Bulletin No 01/95 MDM1-FOX

BULLETIN No BE 01/95 MDM1-FOX**Concerns:**

In part "A" - limiting the range of elevator trim deflection.

In part "B" - strengthening of skeleton elements-to-shell bonding in fuselage tail portion.

S K E T C H " A "

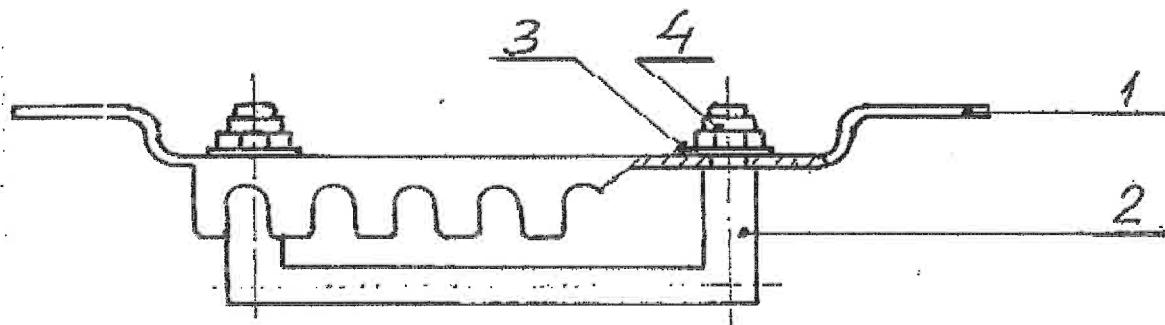
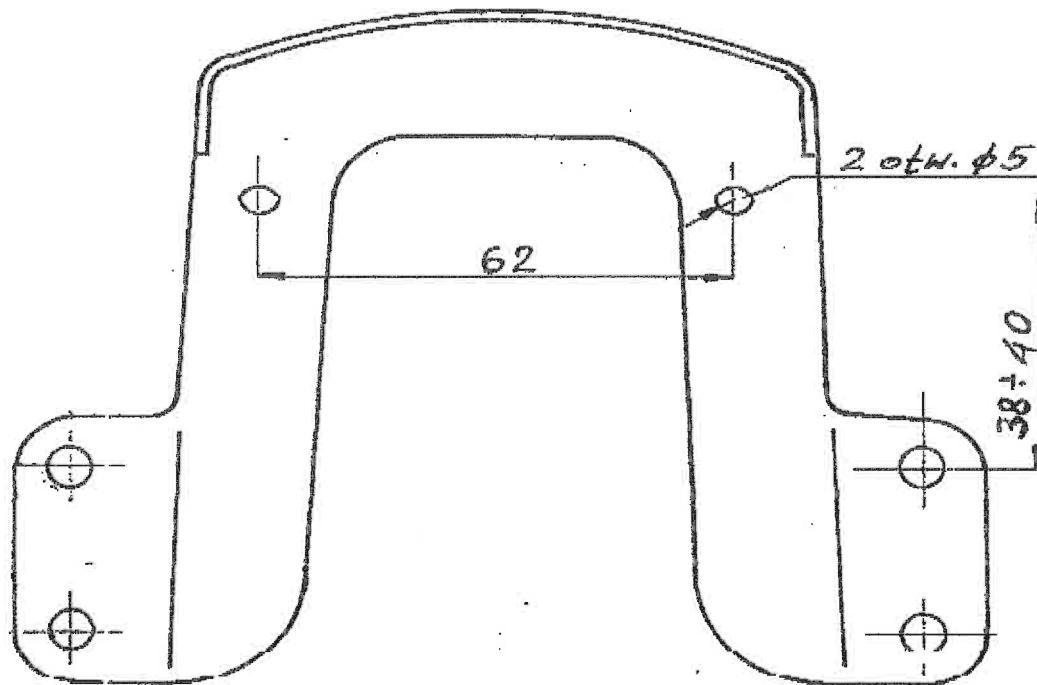
Part "A" - It has been found that the less experienced pilot may set the trimming spring beyond the allowed deflection range. In this case, on certain gliders, the control column free deflections for aileron control could be limited.

To console detail 1 (drawing No B2-10.25.02) , fixing the position of trimming spring , a bow detail 2 , preventing the trim deflection beyond the allowed range , has been added . In the console prepare openings for bow installation , and next install the bow according to sketch " A " .

1	Console	xxxx
2	Bow	1 pc
3	Washer S, 3x1	2 pcs
4	Nut MS	2 pcs

SKETCH "B"

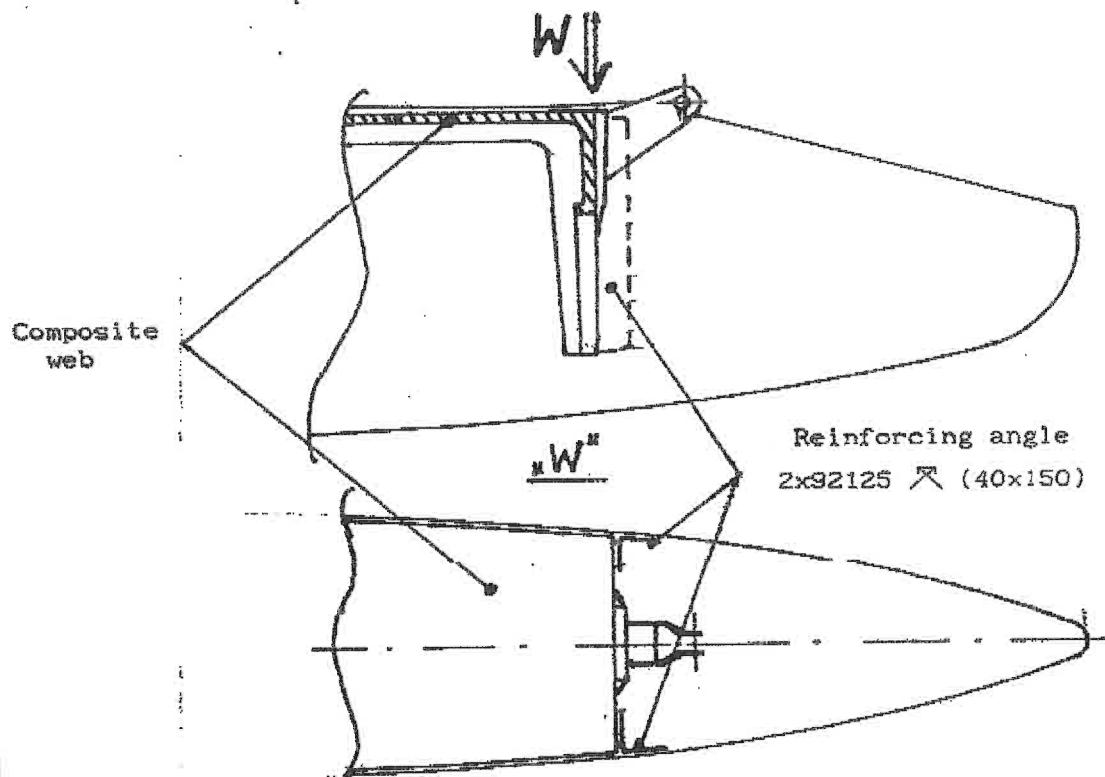
Part "B" - In operation it has been found that the to energetic ground handling, employing the hook and handle located in fuselage tail may lead to damages of glue bonding, joining the skeleton structure with fuselage shell (see sketch "B").

To strengthen the bonding between B2-21.00.03 web and fuselage shell introduction of angles , of 92125 Interglass glass fabric , glued with epoxy resin acc. to the following sketch is recommended .
